# SITE SERVICING AND SWM STUDY MEMORANDUM

SUBJECT: Proposed Amendment to 129 Main Street Site Plan Application  
City File Number: D07-12-10-0196

OUR FILE: DSEL Project No.15-813

DRAWN BY: A.J.G.	CHECKED BY: A.D.F.	DRAWING NO: SWM-1	SHEET NO: 1 of 1
DESIGNED BY: A.J.G.	CHECKED BY: A.D.F.	SCALE: 1:100	DATE: DECEMBER 2018

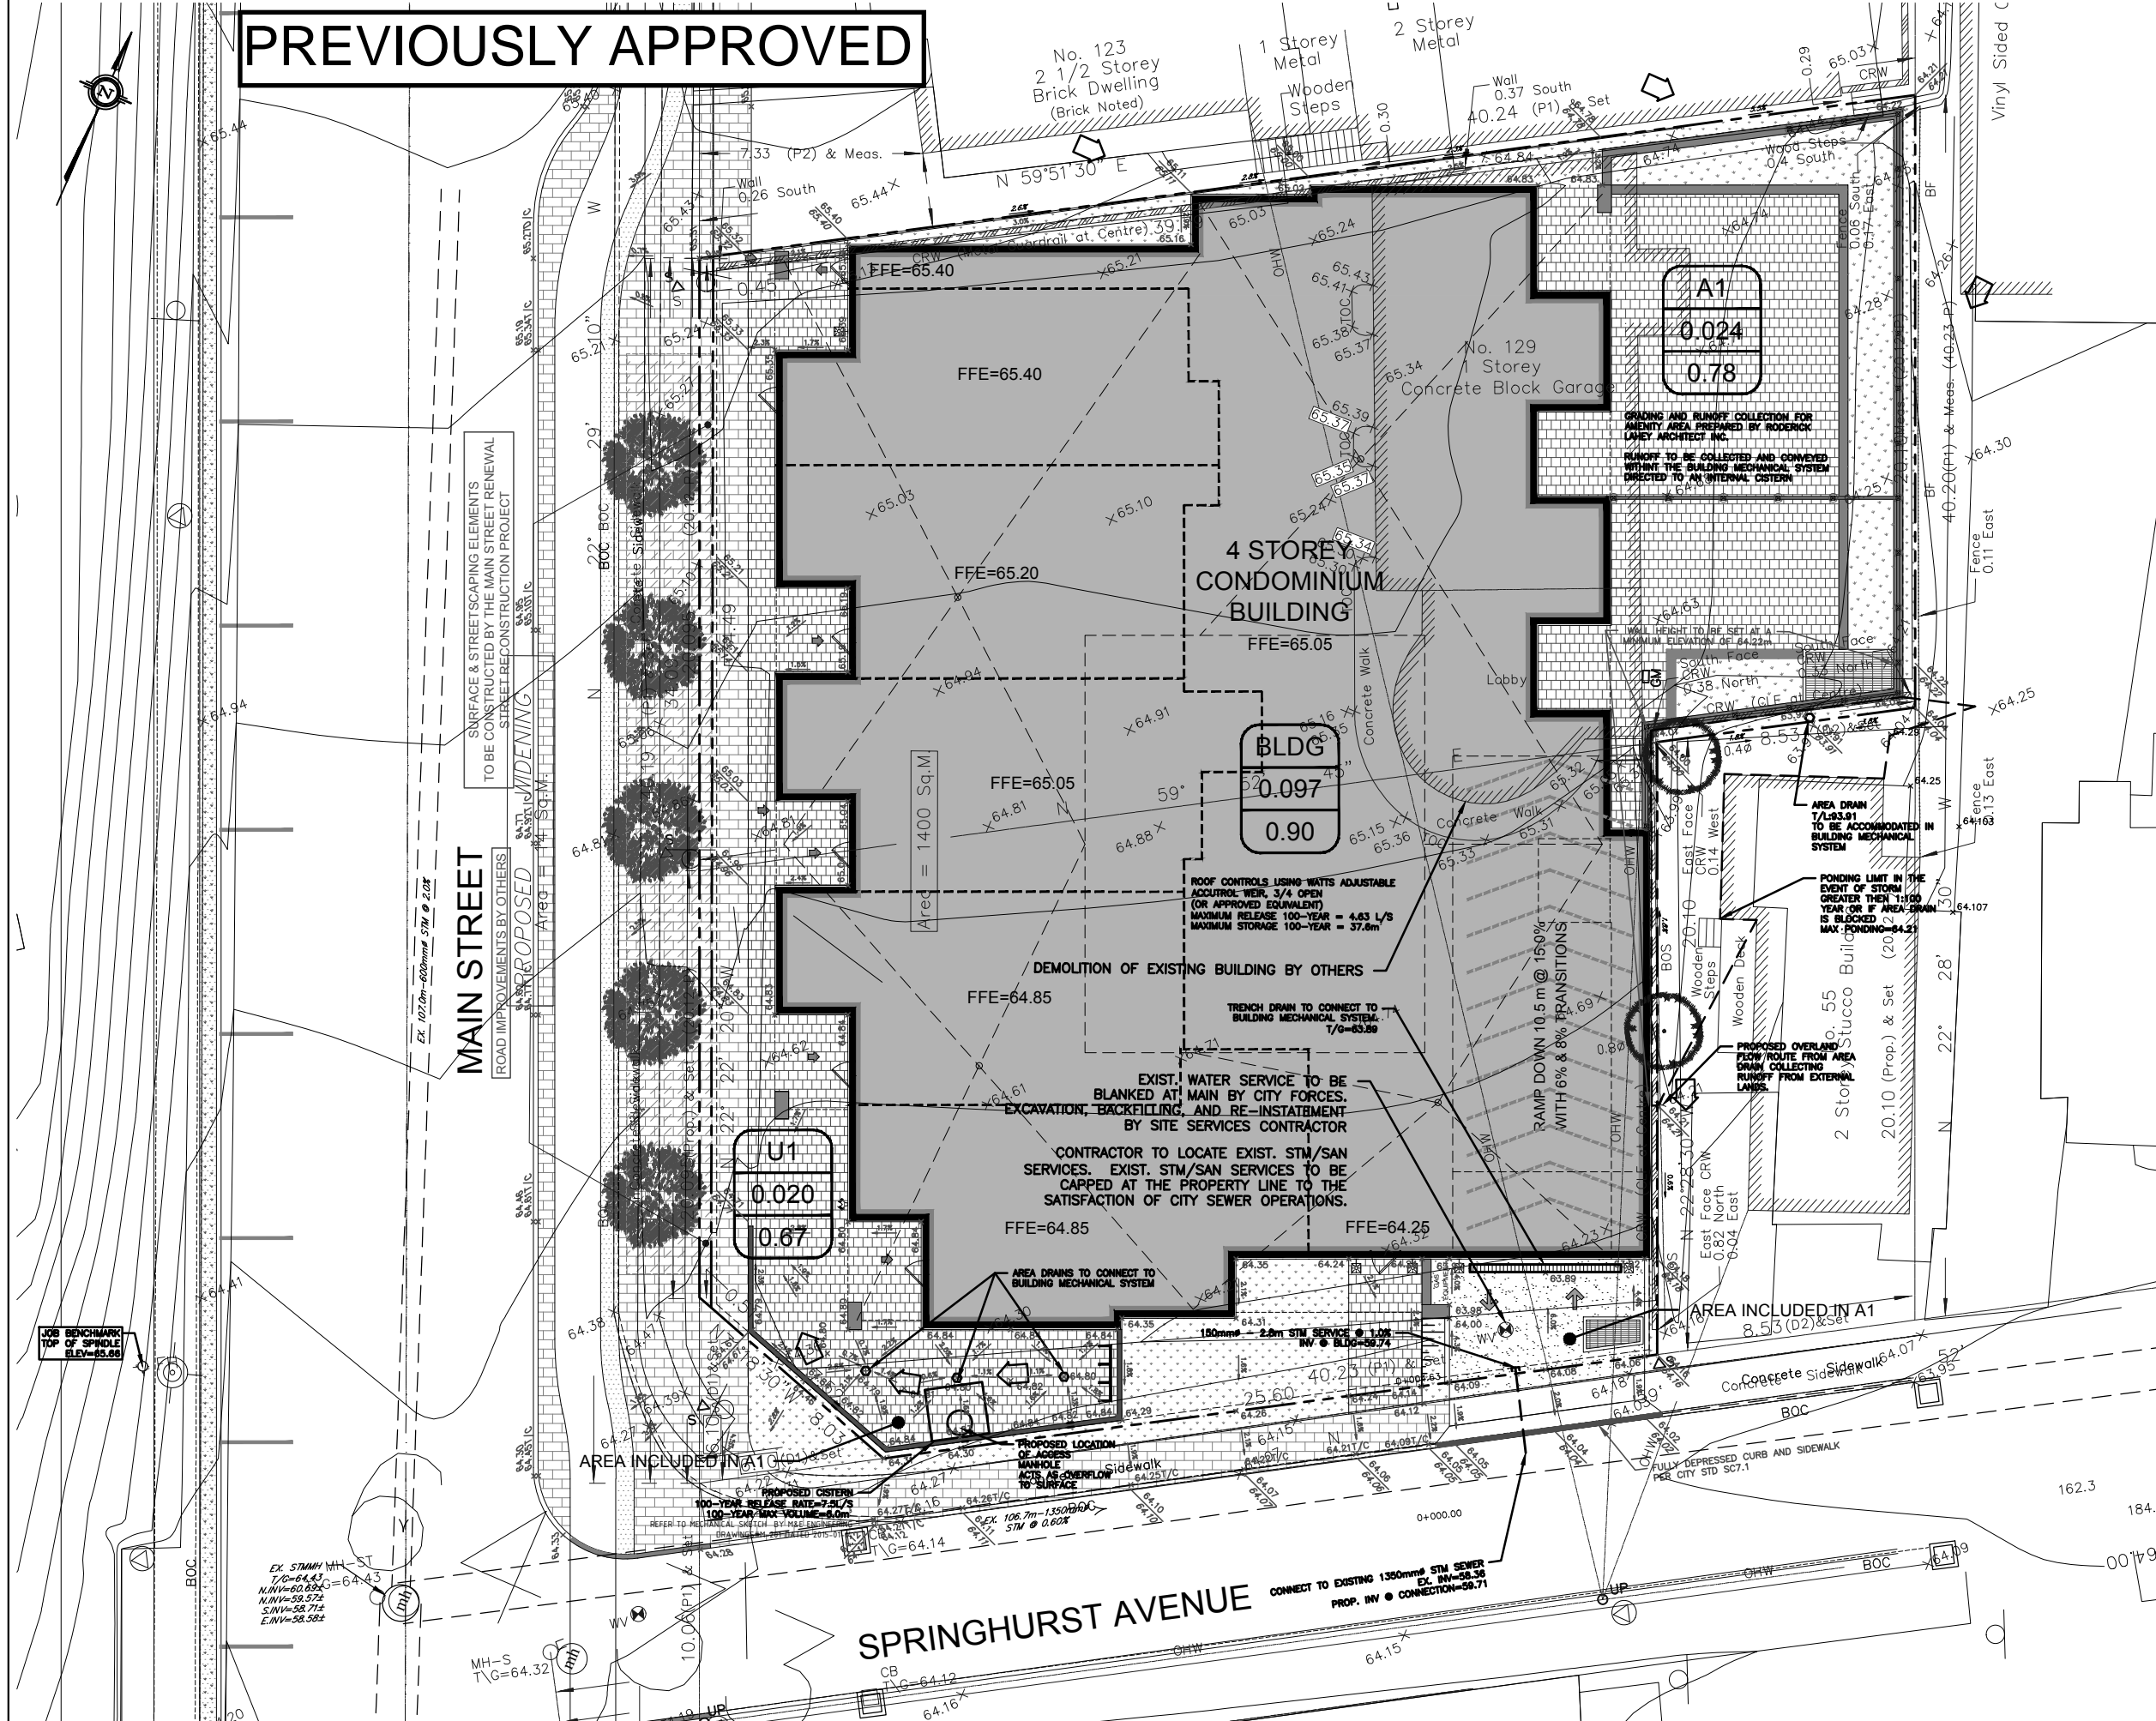
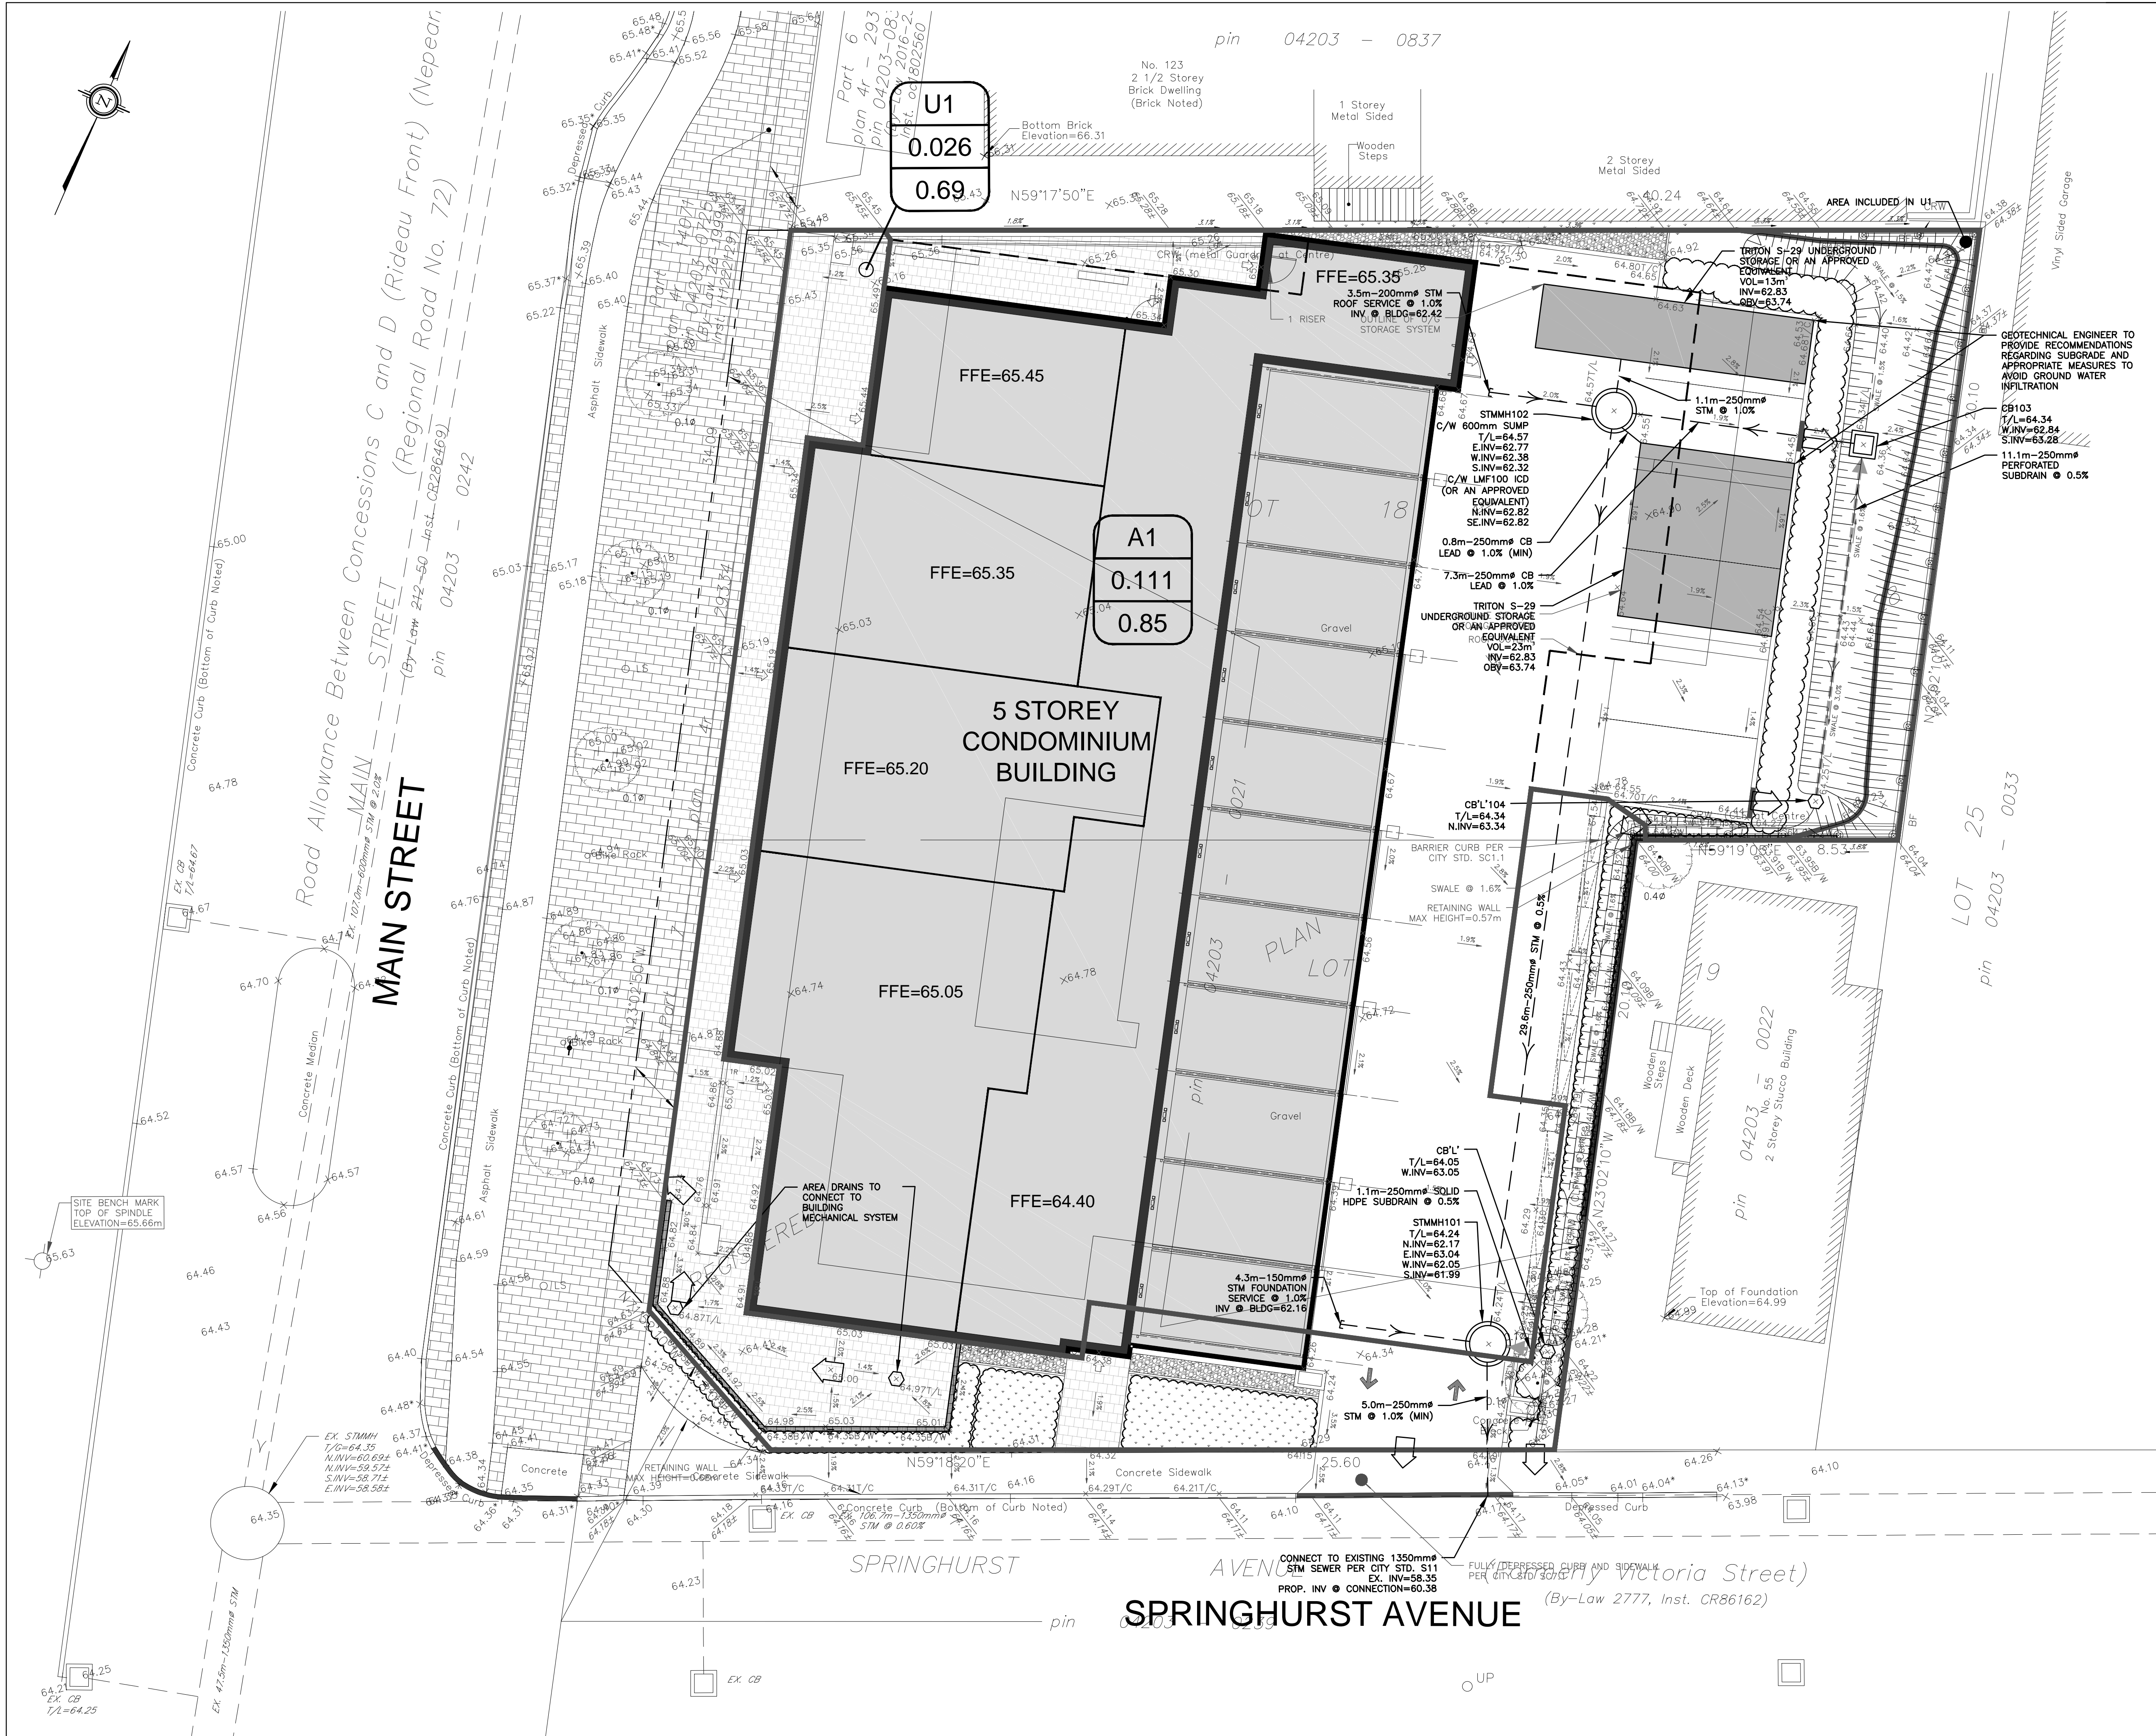
The previously approved storm calculation sheet and associated Stormwater Management Plan, **SWM-1** dated January 15<sup>th</sup>, 2016 is attached for reference. The established allowable release rate for the subject site was determined to be **20.4 L/s**; employing the City of Ottawa IDF parameters for a 5-year storm based on a rational method coefficient of 0.50 with a calculated time of concentration equal to or greater than 10 minutes for **0.14 ha** of the subject site.

Based on the revised calculations the established allowable release rate has been determined as **19.7 L/s**, employing the City of Ottawa IDF parameters for a 5-year storm based on a rational method coefficient of 0.50 with a calculated time of concentration equal to or greater than 10 minutes for **0.136 ha** of the subject site. The reduction in area is a result of the Main Street road widening limits.

Area A1, shown by drawing **SWM-1**, is tributary to the internal storm sewer connecting to Springhurst Avenue. A Triton S-29 underground storage systems or an approved equivalent storage system will provide **36.0 m<sup>3</sup>** of underground storage and stormwater flow will be attenuated by a Tempest **LMF90 ICD** at the outlet side of STMMH102. The attached storm calculation sheets illustrate the existing approved plan and proposed amendment. An updated **SWM-1** drawing dated December 2018 and calculation sheet is included in **Appendix D**.

Approximately **35.6 m<sup>3</sup>** of underground storage is required and will be provided via a **36.0 m<sup>3</sup>** Triton S-29 storage system, or an approved equivalent, to meet the established release rate of **19.7 L/s**.

No.	BY	YY.MM.DD	DESCRIPTION
4	A.J.G.	18.12.12	REVISED PER SITE PLAN AMENDMENT
3	S.L.M.	16.01.15	UPDATED AS PER CITY COMMENTS/ISSUED MYLAR PRINTING
2	S.L.M.	16.01.14	UPDATED AS PER CITY COMMENTS/ISSUED FOR MUNICIPAL REVIEW
1	S.L.M.	15.11.30	SITE PLAN AMENDMENT/ISSUED FOR MUNICIPAL REVIEW
